International Conference on Case Histories in  
Geotechnical Engineering

## Discussions and Replies

Multiple Authors

Fig. 3 Factor of safety with slip circle.

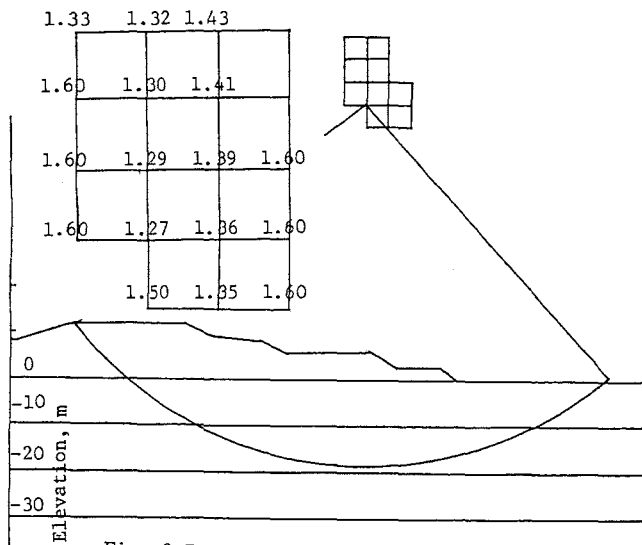
Is  $\phi$  the effective peak, post peak, or residual effective angle of shearing resistance? I am also surprised at the low factor of safety (1.11) which the author states as showing that a 4 m high bank could have been built. In my experience a factor of safety of this magnitude is no guarantee that failure will not occur. I would also like to ask the authors to give the length of the original bank, whether they can explain why failure occurs at this particular location, and the present use of the embankment.

Fig. 1 Soil parameters for design.

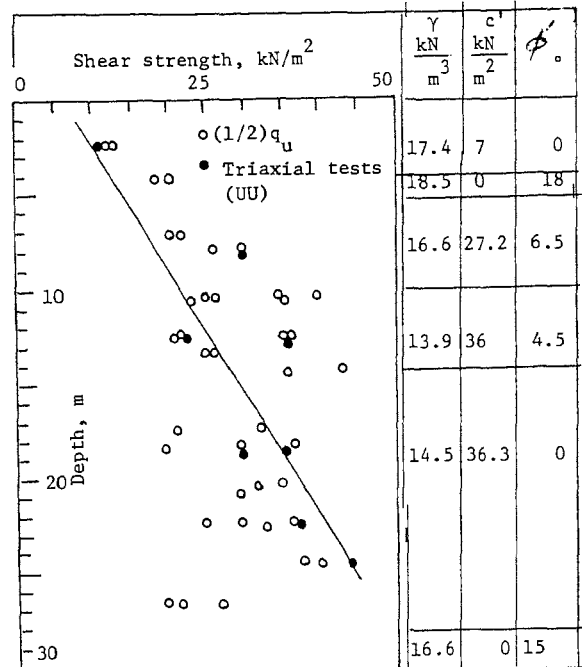
In addition, the author's comments on the strength parameters shown in Fig. 1 would be informative especially in relation to the low drained friction angles recorded. Also, the dependence of drained cohesion on water content, as is the case for quick clays, would not appear to apply here as suggested by the values of unit weight.

I am afraid that the discussor could not understand fully the intention of the author. The author wanted to explain that this deep seated base failure with sustained shear stress along the bottom of the clay layer started by the unbalanced earth pressures on assumed vertical wall I and II. The discussor pointed out that the progressive failure might take place. The author agree with him. But it should be noticed that the incipient failure took place at the bottom of the clay layer and not at a point on the slip circle with minimum factor safety. Shear resistance along the actual sliding surface was not static but kinetic. The failure was dynamic and progressive one but not the static one. Therefore, the residual strength has no direct connection with resistance during rapid movement. The author's idea is stated in the following paper. "Kinetic friction in Landslides, IX ICSMFE Vol. 2, p.71 by M. Fukuoka". "Oral discussion, X ICSMFE, Vol. , p. 585.

Fig. 2 Time-settlement curves.

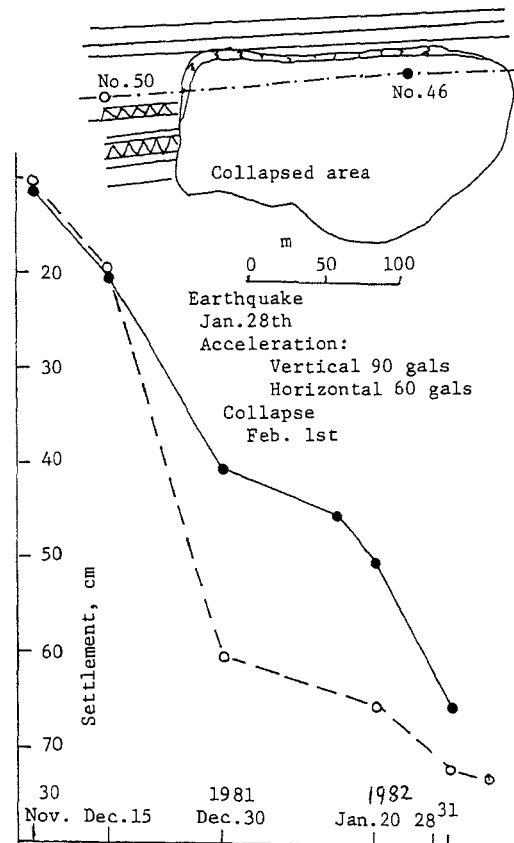
The author's comments on the possible triggering effect of the small seismic event which occurred several days prior to failure would be of interest. Examination of the time-settlement curve for point Q before collapse shows that several days prior to failure the settlement rate increased.

The earthquake might cause increase of pore water pressure and result in increasing shear stress and reducing shear resistance, but it is not very clear. Time settlement curve could have not been used for predicting rupture. Figure 2. shows time settlement curves at the Stations 46(collapsed) and 50 (safe). No evident increase of settlement was observed before the slide. No cracks were observed on the surface of the embankment.

Fig.9:Major principal stresses in the embankment and its foundation

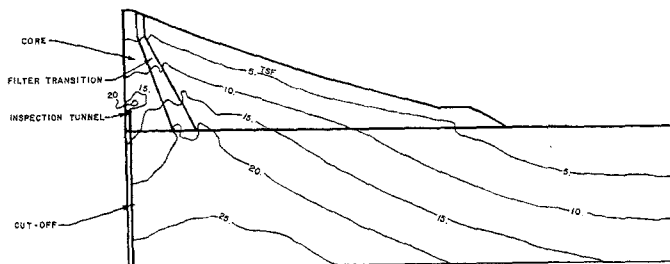
The author concludes that the concentrated leaks were travelling in "a set of cracks (filled with loose muddy material), or decompressed layers distributed erratically...". He also concludes that these "... can be attributed to arching ..." caused by greater compression of the central earth core than adjacent granular shells. The writer agrees completely that all the evidence supports these conclusions, and that there is essentially no other tenable hypothesis to explain the conditions which developed. Also, the finite element method calculations show that such arching can easily occur in central core dams of typical embankment materials (2).

The effect of the valley shape on the stress distribution and deformation of the embankment was analyzed (Lefebvre et al. 1977) and monitored by a set of instruments (Dascal 1973). It should be mentioned that one of the factors considered in adopting a curved embankment, was the closure of eventual tension cracks by the deformation (flattening) of the dam's curvature. Neither the finite element analysis nor the instruments results have indicated the development of tension zones in the embankment. As mentioned in the paper, the weakness zones (cracks, fissures, etc) seem to have a horizontal or sub-horizontal position, and are situated at a depth of more than 30 m (100 ft) below the crest. These weakness zones are distributed along the entire length of the embankment. Their characteristics are inconsistent with those of tension cracks, which develop at the top and near the abutments of a dam and have in general a vertical or quasi-vertical orientation.

Fig.10:Pore pressure at the upstream and downstream zone of the core (elevation 550')

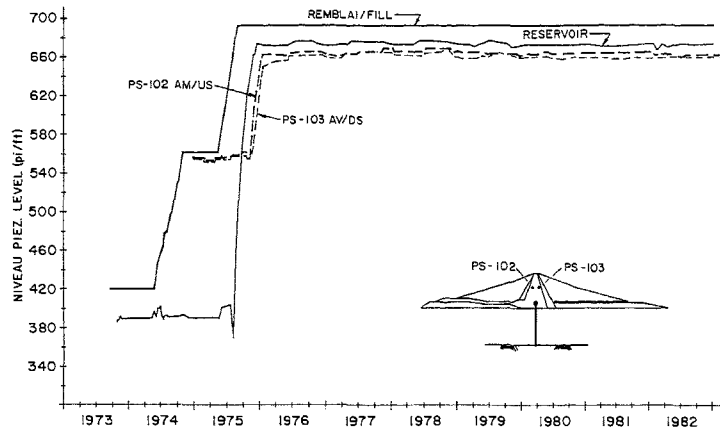
Most of the piezometers in the upper half of the dam core are located at either Elevation 550 (75 feet below maximum reservoir level) or at Elevation 625, Figure 3. As seen in Figure 8, piezometers at the downstream face of the core at Elevation 550 followed the first reservoir filling during the last part of 1975 with measured pressure head of about 8 to 10 feet lower than the reservoir level. (For piezometers at Elevation 550, there had been essentially zero measured pressure before the reservoir was raised above Elevation 550.) When the reservoir stopped rising (became full) in December 1975, the measured pressures in the downstream piezometers also stopped increasing, with apparently zero time lag. Then for four years starting in January 1976 the reservoir was kept nearly full, with level generally between Elevation 672 and 675, Figure 8. During this four year period the pressure head in the downstream piezometers at Elevation 550 remained nearly constant, varying only to follow the small variations in the reservoir level. During this four year period of full reservoir the downstream piezometers at Elevation 550 measured pressure heads of about 8 to 11 feet below the reservoir level, and upstream piezometers at Elevation 550 measured average pressures only a foot or two higher than the downstream pressures.

The measured head loss in the relatively short length of the core remaining downstream of the downstream piezometer was about  $668 - 665 = 138$  feet. We can only speculate about the distribution of the pressure head in the thin strip of impervious core at its downstream face, downstream of the downstream piezometer. The writer believes that it is quite likely that if piezometers had been located in the core at Elevation

The author would like to thank particularly Mr. J. Sherard for the valuable supplementary explanations. To emphasize his conclusions fig. 10 is presented, illustrating the pore pressures recorded at elevation 550 for the last 10 years. As can be seen since the reservoir's impounding the pore pressures have remained practically constant (small variations due to reservoir level variations) with only a few feet head loss between the two piezometers. The adequate filter material by preventing the migration of the core's fine particles, allowed the buildup of a thin impervious zone at the core-filter interface, which remained stable for such a long time period in spite of being submitted to a very high hydraulic gradient.
